CASE COMMENT REPORT

CASE NO. UDP-S25035

CASE	UDP-S25035
PROJECT NAME	The Estates at Riverland
APPLICATION TYPE	Site Plan Level II
APPROVAL LEVEL	Development Review Committee
REQUEST	11-Unit Townhome Development
APPLICANT	Arman Shahbazyan
AGENT	Gevorg Shahbazyan
PROPERTY ADDRESS	1841 SW 29 Avenue
ABBREVIATED LEGAL DESCRIPTION	Rohan Acres 22-43 B LOT 4 BLK 2
ZONING DISTRICT	Irregular Residential (RD-12.22) District
LAND USE	Irregular Residential 12.22
COMMISSION DISTRICT	4 – Ben Sorensen
NEIGHBORHOOD ASSOCIATION	Chula Vista Isles Homeowners Association
SUBMITTED	September 11, 2025
COMPLETENESS ISSUED	September 15, 2025
STATE STATUTE 166.033 EXPIRATION	January 17, 2026
CASE PLANNER	Adam Schnell, Urban Planner III

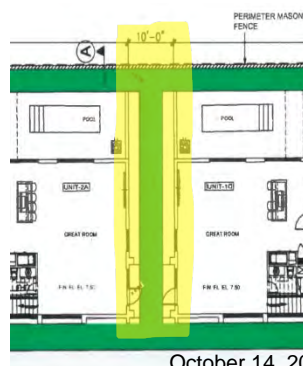
Please provide specific details of solid waste and recycling collection per building

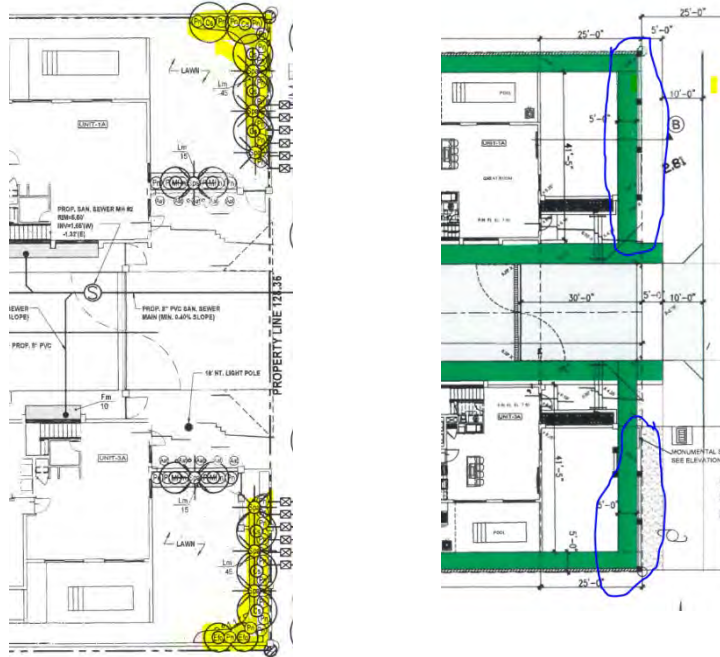
- a. The easement space between Building 1 and Building 2, is not sufficient. Each building requires a 5-foot easement, for a total of 10 feet. Widen the easement highlighted below to a total of 10 feet in width and remove all obstructions such as architectural elements.

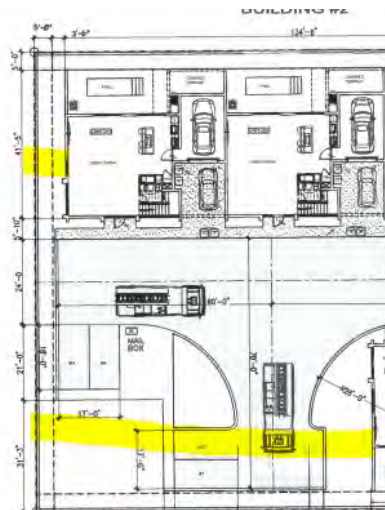
- 8) Provide the following changes to the site plan:
a. Remove all obstructions (trees, fence posts, etc.) located in the required 5-foot pedestrian easement around the perimeter of the property. Only grass and traversable surfaces are permitted within the 5-foot easement area. The plans indicate conflicts between the onsite landscaping and 5-foot easement area. The easement does not need to follow the exterior of the property line and can be adjusted out of the landscape area. The relocation of the landscaping is also possible but would create a visual gap between the fence and landscape hedge. Therefore, adjusting the location of the easement is preferable.

- b. The plans indicated a masonry wall around the perimeter of the property. Provide the proposed height on the site plan and cross sections, detail sheets, and example images of the wall.
c. Consider placing landscaping along the perimeter of the property and moving the five (5) foot easement closer to the units to increase compatibility between the townhouses and surrounding homes.
d. Provide rear yard setback measurements. Missing measurements are identified below.
